Subject: Dynamic Evaluation of Seat Restraint Systems and Occupant Protection on Transport Airplanes

AC No: 25.562-1B
Change: 1

1. PURPOSE.

2. PRINCIPAL CHANGES. Change 1 updates AC 25.562-1B, *Dynamic Evaluation of Seat Restraint Systems and Occupant Protection on Transport Airplanes*, dated January 10, 2006. We have added the change number and date of revision at the top of each changed page. We have also marked the changes with a vertical change bar in the margin. Specifically, Change 1 incorporates the following changes:

Figure 5-2. Structural Test Article Decision Tree for Seat Family

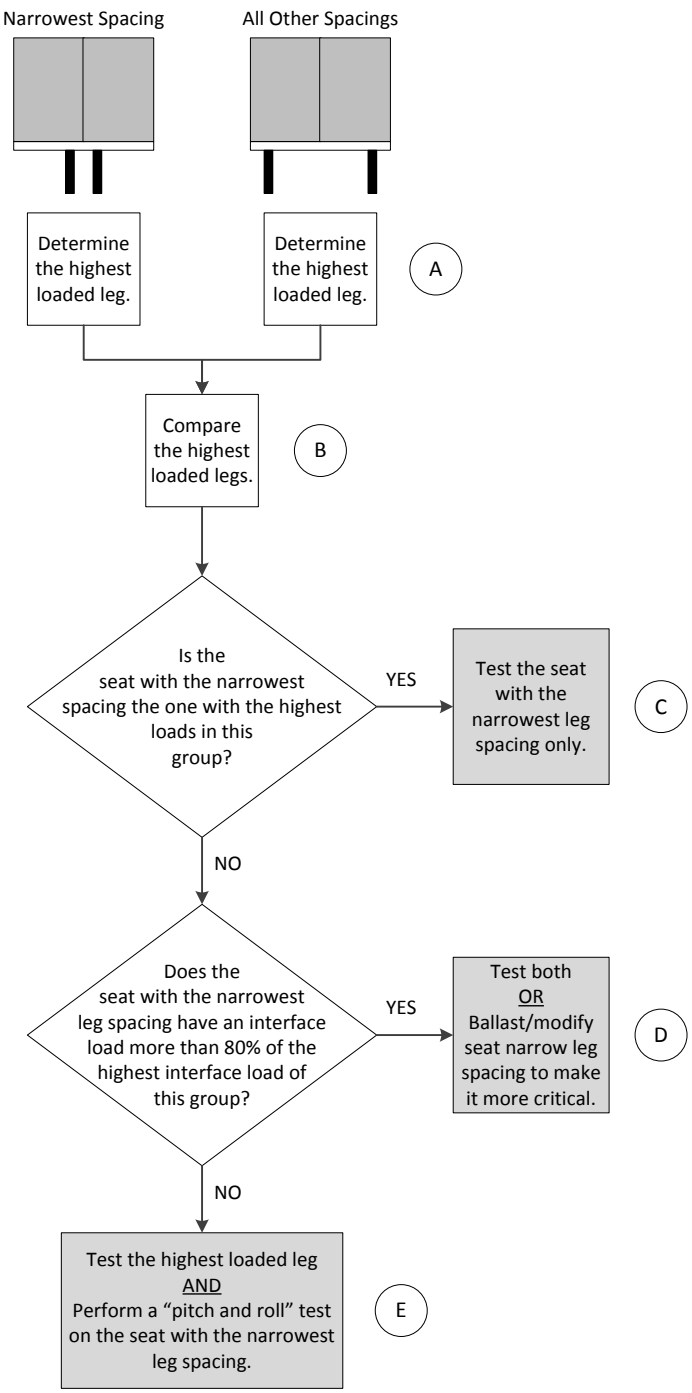
b. Corrects typographical errors in the second question of Figure 5-2. We also redesigned the figure to improve readability.
